# United States Patent and Trademark Office

APPLICATION NO.	FILING DATE	FIRST NAMED INVENTOR	ATTORNEY DOCKET NO.	CONFIRMATION NO.	
10/685,309	10/14/2003	Philip Andrew Frank	005127.00467	9840	
22909 7:	590 07/05/2005		EXAMINER		
BANNER & WITCOFF, LTD. 1001 G STREET, N.W. WASHINGTON, DC 20001-4597		MITCHELL, KATHERINE W			
			ART UNIT	PAPER NUMBER	
,			3677	<u>-</u>	
		·	DATE MAILED: 07/05/200	DATE MAILED: 07/05/2005

Application No.	Applicant(s)	
	10/685,309	FRANK	
Office Action Summary	Examiner	Art Unit	
	Katherine W. Mitchell	3677	
The MAILING DATE of this communication app Period for Reply	ears on the cover sheet with the c	correspondence address	
A SHORTENED STATUTORY PERIOD FOR REPLY THE MAILING DATE OF THIS COMMUNICATION.  - Extensions of time may be available under the provisions of 37 CFR 1.13 after SIX (6) MONTHS from the mailing date of this communication.  - If the period for reply specified above is less than thirty (30) days, a reply If NO period for reply is specified above, the maximum statutory period w  - Failure to reply within the set or extended period for reply will, by statute, Any reply received by the Office later than three months after the mailing earned p

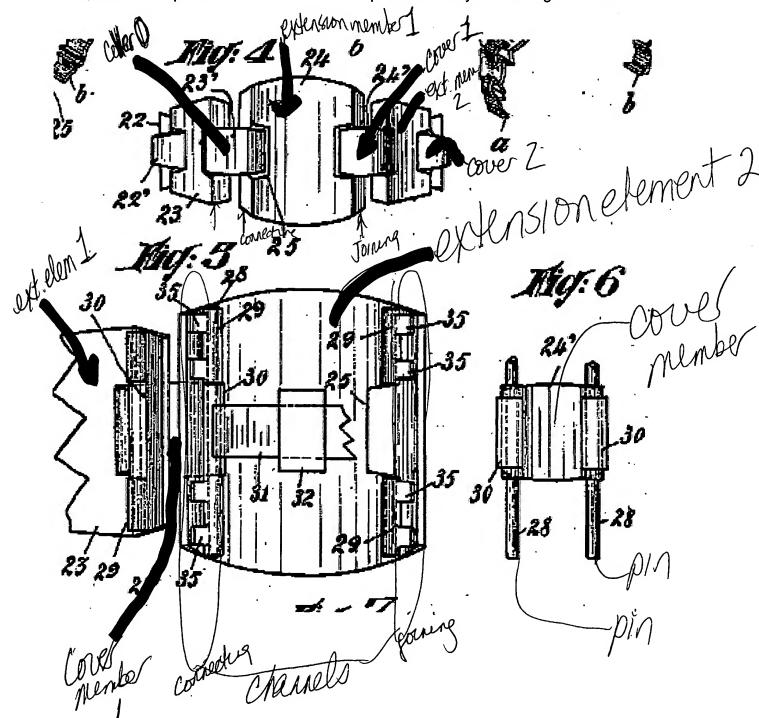
Re claims 29-30, 35-39, 42-45, 52,55,56,57,59,61,62, and 64: Bezault teaches a metal link bracelet which could be used as the bracelet for a wristwatch, as shown in the Figures below. Examiner has marked up the drawings to show what is the cover member, the extension element, the channels, and the pins. However, Bezault does not show the bracelet in combination with a recessed case for a timepiece. Kikuchi Fig 6 shows a link bracelet and timepiece combination. Therefore, it would have been obvious
